# Access Compliance Report

## Public Rights-of-Way

### (Curb Ramps)

Intersection ID: 5859	Main Street: CONIFER_CR	Cross Street: ST_JOSEPH_DR	Location: S
ADA ID: EBF42356BFDB	Ramp Type: Perp	Initial Pass/Fail: Fail	Overall Compliance: No
		Severity Score: 8.75	
Codes/Mitigation Info/Possible Solution		Field Measurements/Component Compliance

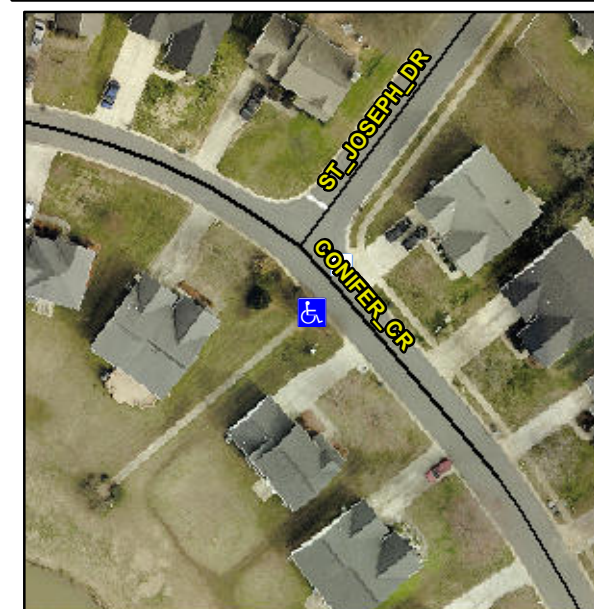
**Remove & Replace Entire Ramp.**

**Not Found, R304.5.1**

Compliance	Description	Data	Compliance	Description	Data
N/A	Ramp Length (in)	40.5	Yes	Ramp Slope (%)	5.3
No	Ramp Width (in)	47.0	Yes	Ramp XSlope (%)	0.1
N/A	Flare Type LT	N/A	N/A	Flare Type RT	N/A
N/A	Flare Slope LT (%)	N/A	N/A	Flare Slope RT (%)	N/A
N/A	Flare Traversable LT?	N/A	N/A	Flare Traversable RT?	N/A
N/A	Landing Length (in)	N/A	N/A	DWS Provided?	N/A
N/A	Landing Width (in)	N/A	N/A	DWS Contrast?	N/A
N/A	Landing Slope (%)	N/A	N/A	DWS Length (in)	N/A
N/A	Landing X Slope (%)	N/A	N/A	DWS Full Width?	N/A
N/A	Landing Curb? (Y/N)	N/A	N/A	DWS Offset (in)	N/A
N/A	Shared Landing?	N/A			
N/A	Gutter Ponding?	N/A	N/A	Gutter Slope (%)	N/A
N/A	Gutter Lip Ht (in)	N/A	N/A	Gutter X Slope (%)	N/A
N/A	Painted X Walk1?	No	N/A	Painted X Walk2?	N/A
	X Walk 1 Direction	To E		X Walk 2 Direction	N/A
N/A	X Walk 1 Width (in)	N/A	N/A	X Walk 2 Width (in)	N/A
	X Walk 1 Slope (%)	3.6		X Walk 2 Slope (%)	N/A
	X Walk 1 X Slope (%)	0.6		X Walk 2 X Slope (%)	N/A
